1980 & 1981 FLT SERVICE INFORMATION

TRANSMISSION BREATHER VENT — 1980 ONLY

Figure 1. Rear Clutch Cable Bracket Bolt

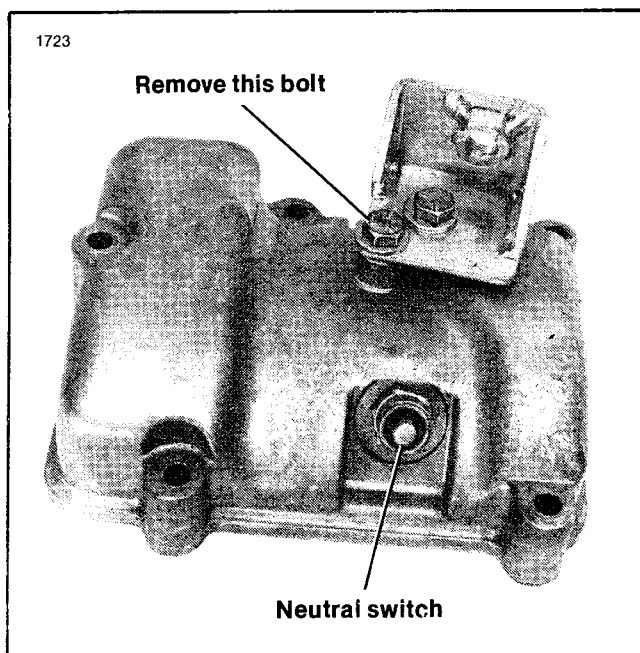
4. See Figure 1. Remove the rearmost clutch cable bracket bolt (1/4-20 x 5/8 in.). See Figure 2. Drill through the bolt head with a 1/16 in. dia. drill. Drill a second 1/16 in. dia. hole lengthwise from the bottom of the bolt to meet the cross hole in the head. Do not drill this hole completely through the head

Figure 2. Clutch Cable Bracket Bolt Part No. 3751

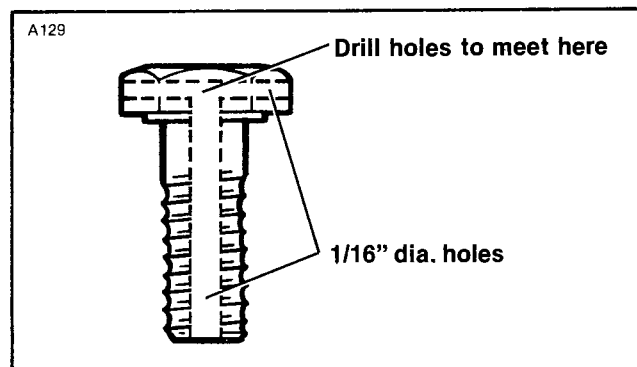
of the bolt. Clean the bolt with compressed air to remove all shavings. A drilled 1/4-20 x 5/8 bolt can be ordered under Part No. 3751.

Figure 3. Drilling Vent Hole in Transmission Cover

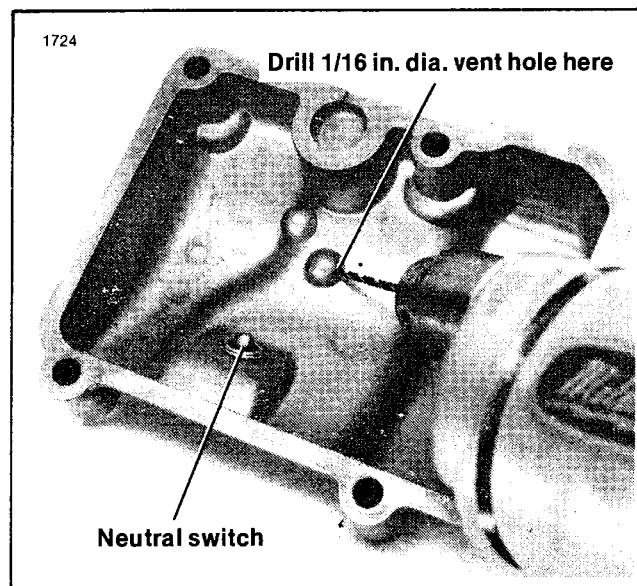
5. See Figure 3. Drill a 1/16 in. dia. hole at a slight angle through the side of the boss located on the underside of the transmission cover into the rearmost clutch cable bracket bolt hole. Clean all metal shavings from the hole with compressed air.
6. Install the drilled bolt in its original location and install the cover and starter solenoid as described in the 1981 FLT Service Manual.
